Access Compliance Report Public Rights-of-Way (Curb Ramps)

Main Street: PERDIDO_ST Cross Street: LULLABY_LN Location: NE

ADA ID: RPAT220203160108 Ramp Type: Type 4 - Parallel Initial Pass/Fail: Fail Overall Compliance: No Severity Score: 4

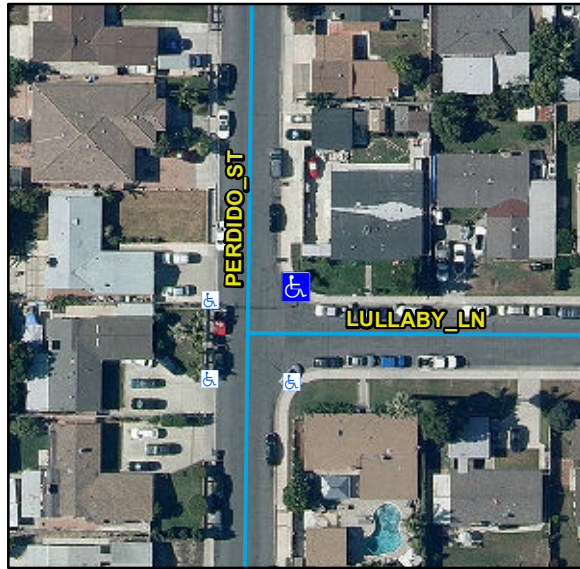
Compliance	Description	Data	Compliance	Description	Data
N/A	Ramp Length LT (in)	86	N/A	Ramp Length RT (in)	86
No	Ramp Width LT (in)	47	No	Ramp Width RT (in)	47
Yes	Ramp Run Slope LT (%)	7.8	Yes	Ramp Run Slope RT (%)	7.4
Yes	Ramp Cross Slope LT (%)	0	Yes	Ramp Cross Slope RT (%)	1.1
N/A	Landing Present	N/A	N/A	DWS Provided	N/A
N/A	Landing Length (in)	N/A	N/A	DWS Contrast	N/A
N/A	Landing Width (in)	N/A	N/A	DWS Length (in)	N/A
N/A	Landing Run Slope (%)	N/A	N/A	DWS Full Width	N/A
N/A	Landing Cross Slope (%)	N/A		DWS Offset Type	N/A
N/A	Landing Movement Obstructed?	N/A	N/A	DWS Offset Left (in)	N/A
	Landing Movement Type	N/A	N/A	DWS Offset Right (in)	N/A
N/A	Landing Shared	N/A			
N/A	Clear Space	Yes			
N/A	Clear Space To Crosswalk (in)	N/A			
N/A	Marked Crosswalk 1	No	N/A	Marked Crosswalk 2	No
	Crossing 1 Direction	S		Crossing 2 Direction	W
	Marked Crosswalk 1 Width (in)	N/A		Marked Crosswalk 2 Width (in)	N/A
N/A	Ramp Inside Crosswalk 1	N/A	N/A	Ramp Inside Crosswalk 2	N/A

Remove & Replace Curb Ramp With Two New Directional Ramps or Equivalent.
